# Access Compliance Report

## Public Rights-of-Way

### (Curb Ramps)

| Intersection ID: 14014 | Main Street: N_SHARON_AMITY_RD | Cross Street: WILORA_LAKE_RD | Location: SE           |

| ADA ID: 71F8D0279EB0   | Ramp Type: Perp                | Initial Pass/Fail: Fail      | Overall Compliance: No |

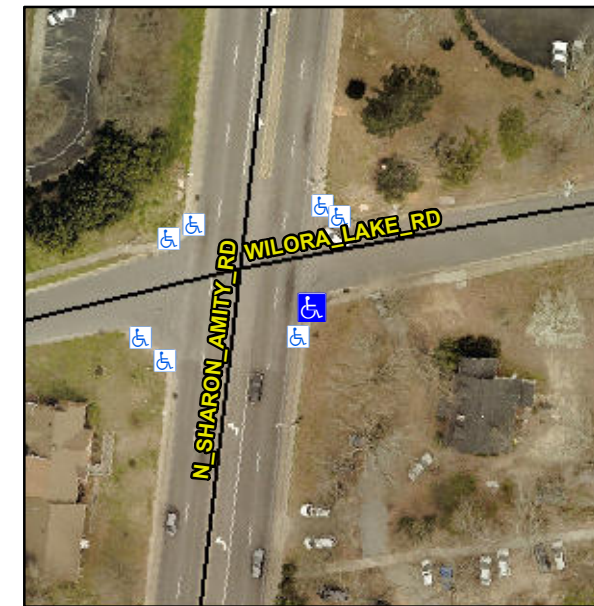
**Remove & Replace Entire Ramp.**

**Not Found, R304.2.2**

| Compliance | Description           | Data  | Compliance | Description                 | Data |
|------------|-----------------------|-------|------------|-----------------------------|------|
| N/A        | Ramp Length (in)      | 60.0  | No         | Ramp Slope (%)              | 10.2 |
